Access Compliance Report

Public Rights-of-Way

(Curb Ramps)

Intersection ID: 21898	Main Street: FOUNTAINHILL RIDGE RD	Cross Street: MILL POND RD	Location: S
ADA ID: 3EE78C64BCF9	Ramp Type: PerpDiag	Initial Pass/Fail: Fail	Overall Compliance: No
Codes/Mitigation Info/Possible Solution			Severity Score: 25
			Field Measurements/Component Compliance

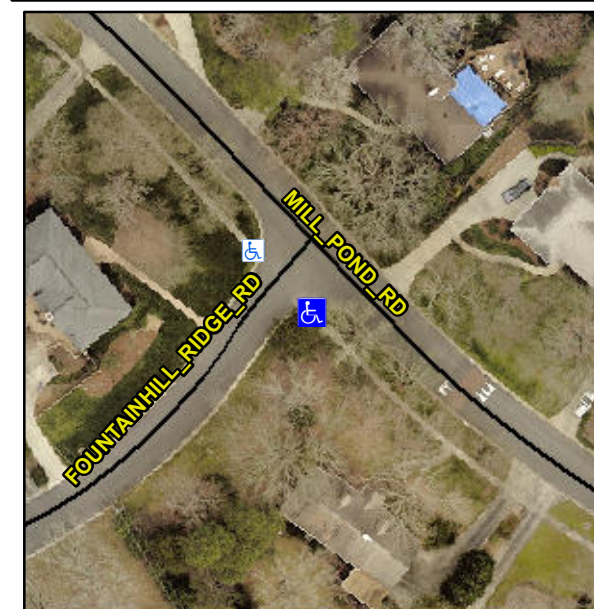
Not Found, R304.2.2

Compliance	Description	Data	Compliance	Description	Data
N/A	Ramp Length (in)	94.0	No	Ramp Slope (%)	13.2
Yes	Ramp Width (in)	48.0	Yes	Ramp XSlope (%)	1.8
N/A	Flare Type LT	N/A	N/A	Flare Type RT	N/A
N/A	Flare Slope LT (%)	N/A	N/A	Flare Slope RT (%)	N/A
N/A	Flare Traversable LT?	N/A	N/A	Flare Traversable RT?	N/A
N/A	Landing Length (in)	N/A	N/A	DWS Provided?	N/A
N/A	Landing Width (in)	N/A	N/A	DWS Contrast?	N/A
N/A	Landing Slope (%)	N/A	N/A	DWS Length (in)	N/A
N/A	Landing X Slope (%)	N/A	N/A	DWS Full Width?	N/A
N/A	Landing Curb? (Y/N)	N/A	N/A	DWS Offset (in)	N/A
N/A	Shared Landing?	N/A			
N/A	Gutter Ponding?	N/A	N/A	Gutter Slope (%)	N/A
N/A	Gutter Lip Ht (in)	N/A	N/A	Gutter X Slope (%)	N/A
N/A	Painted X Walk1?	No	N/A	Painted X Walk2?	No
	X Walk 1 Direction	To NE		X Walk 2 Direction	To NW
N/A	X Walk 1 Width (in)	N/A	N/A	X Walk 2 Width (in)	N/A
	X Walk 1 Slope (%)	4.3		X Walk 2 Slope (%)	4.3
	X Walk 1 X Slope (%)	6.9		X Walk 2 X Slope (%)	2.2

Remove & Replace Curb Ramp With Two New Directional Ramps or Equivalent.
